AMEREN/UE
DOCUMENT CONTROL SYSTEM
DOCUMENT TRANSMITTAL

TEMPORARY CHANGE NOTICE REQUEST FORM
(Instructions for Completion Following)

TCN NO. 03-0073

1. PROCEDURE NUMBER EIP-22-00201 REVISION NO. 036
PROCEDURE TITLE Notifications

Telephone Flowchart

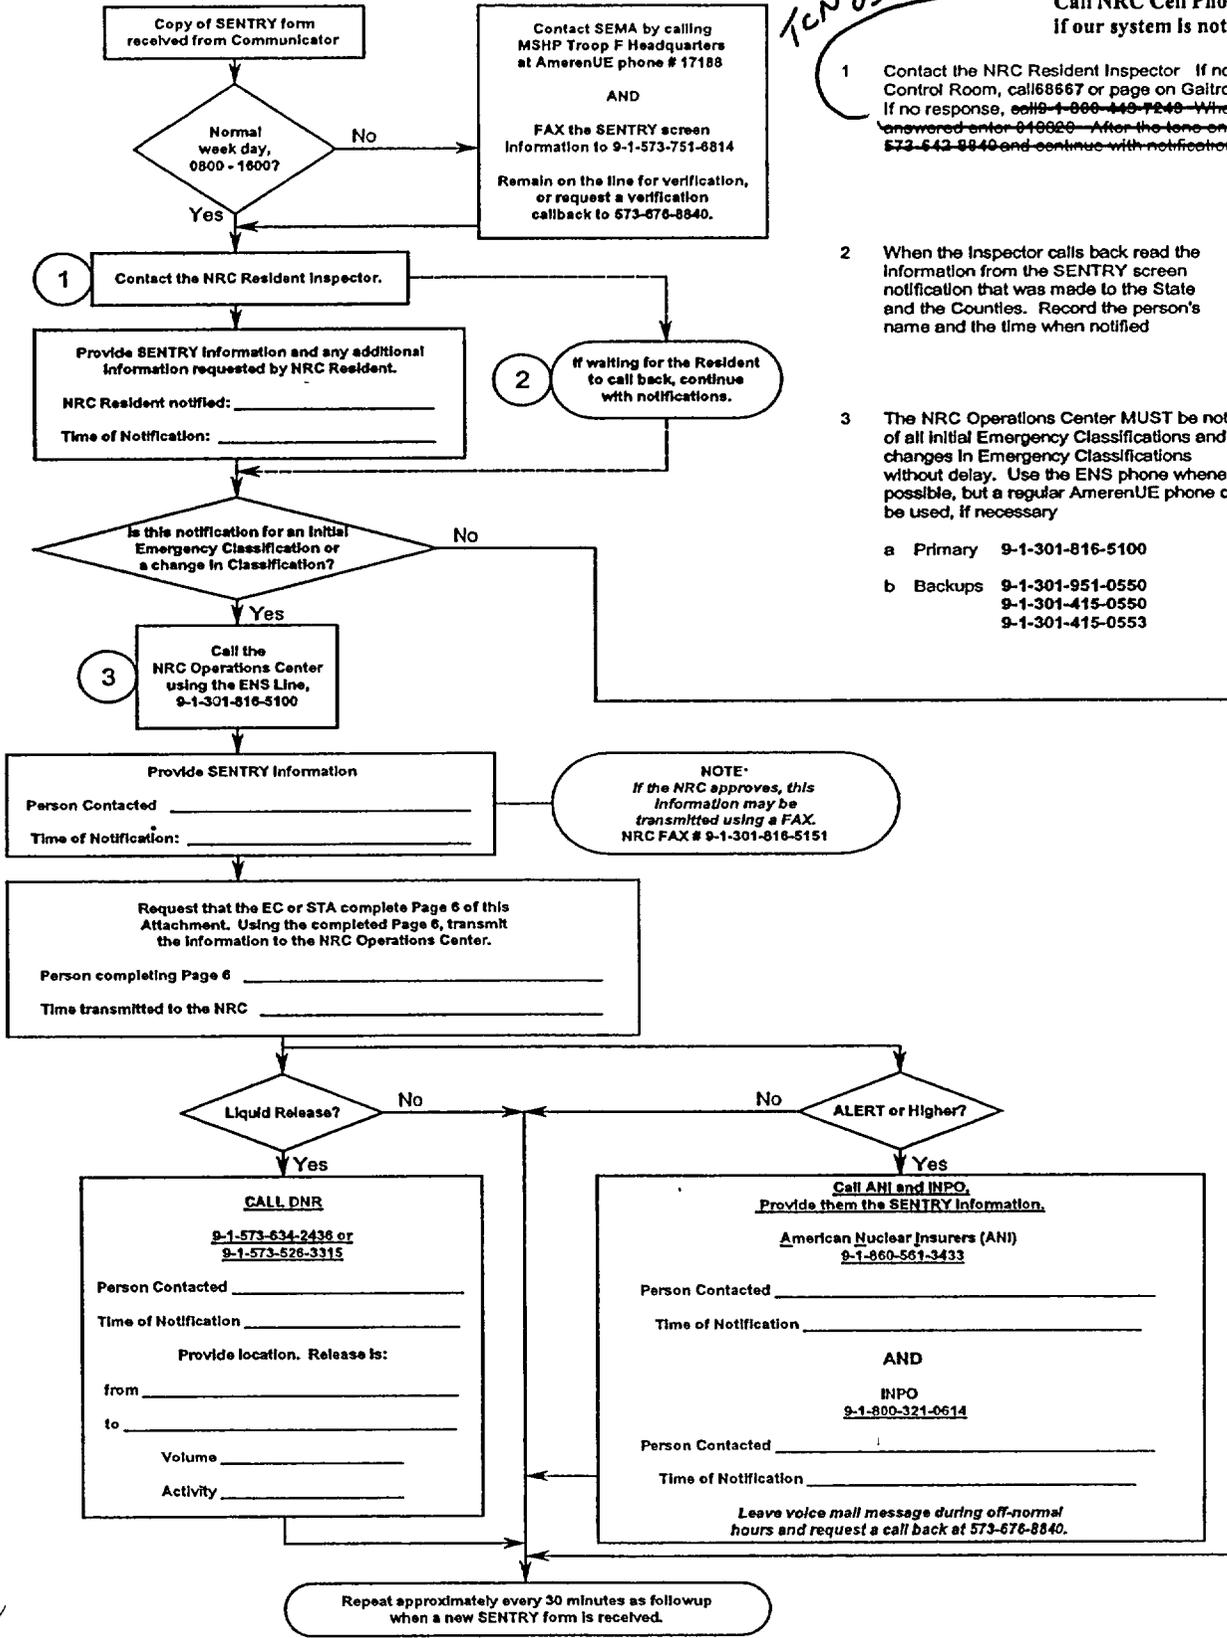
Page using our email system.
 Michael Peck email or 573-808-9231
 John Hanna email or 573 808 9236
 Continue with notifications
 Call NRC Cell Phone 573-356-4600
 If our system is not operable

TCN 03-0073 →

1 Contact the NRC Resident Inspector. If not in the Control Room, call 68667 or page on Galtronics. If no response, call 9-1-866-440-7240. When answered enter 046620. After the tone enter 573-642-8840 and continue with notifications.

EOF NOTIFICATION PACKAGE

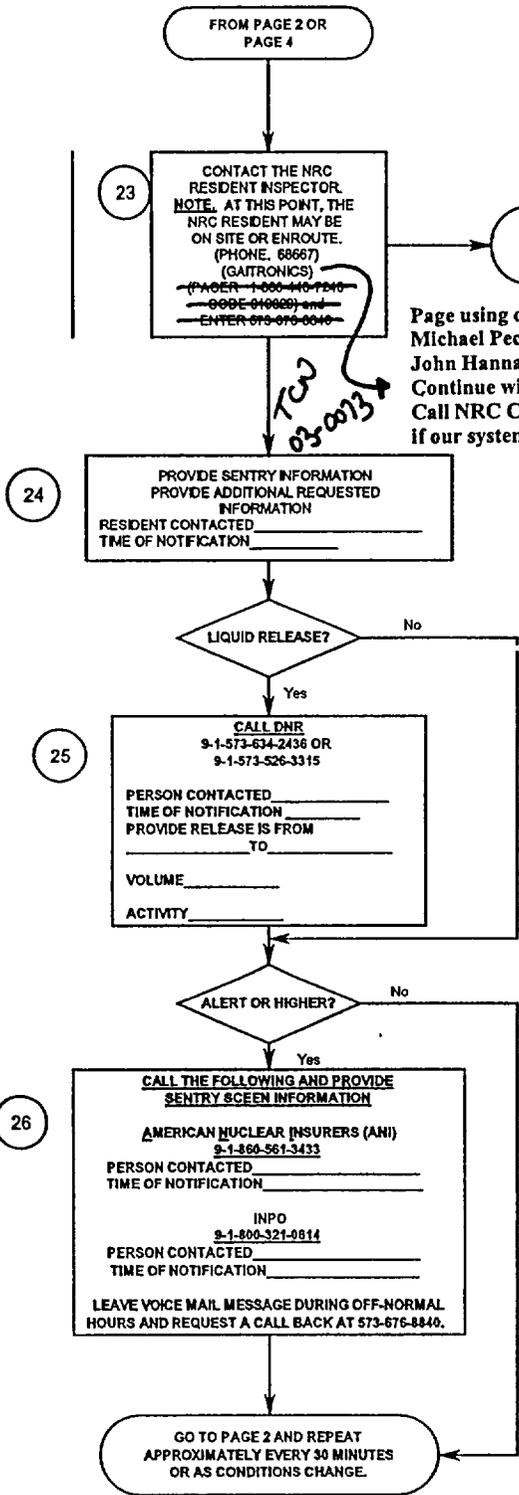
Page using our email system.
 Michael Peck email or 573-808-9231
 John Hanna email or 573 808 9236
 Continue with notifications
 Call NRC Cell Phone 573-356-4600
 if our system is not operable

TCW 03-0073 →

23 Contact the NRC Resident Inspector by phone (68667, galtronic, or page using ~~1-800-440-7243 code 040920, and enter 573-676-8840~~)
